Subject: Reduced Seismic Criteria at Commonwealth Edison Nuclear Facilities

RESPONSE TO NRC QUESTIONS ASKED AT APRIL 28, 1994
ComEd/NRR MEETING

**ComEd Response to NRC Questions asked at
April 28, 1994 ComEd/NRR Meeting**

Figure 1-1

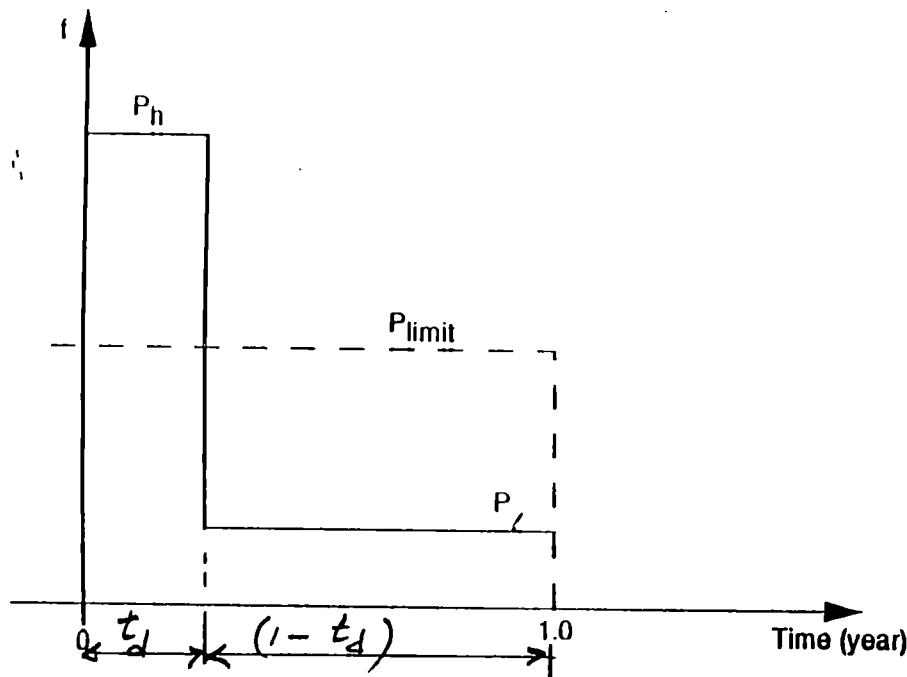
Dr. C. Allin Cornell, in his third party review of ComEd's scale factors has found them to be acceptable. However, Dr. Cornell chose to calculate these factors using a risk averaging method. This method is described in Dr. Cornell's letter of April 25, 1994. Figure 1-1 shows an illustration of the risk averaging concept. Table 1-2 compares the scale factors determined by risk averaging versus the results from the constant probability approach. We conclude that Dr. Cornell's alternative approach does not result in an accurate determination of comparative risk for the following reasons:

To obtain the comparison shown in Table 1-2, the following values are used for the parameters in Figure 1-1:

The parameter $p_{limit} = 2p_{SSE}$ is particularly significant. It shows that ComEd scale factors is associated with a frequency of exceedance per year that is smaller than $2p_{SSE}$, (because risk averaging scale is smaller than ComEd scale factors at $p_{limit} = 2p_{SSE}$).
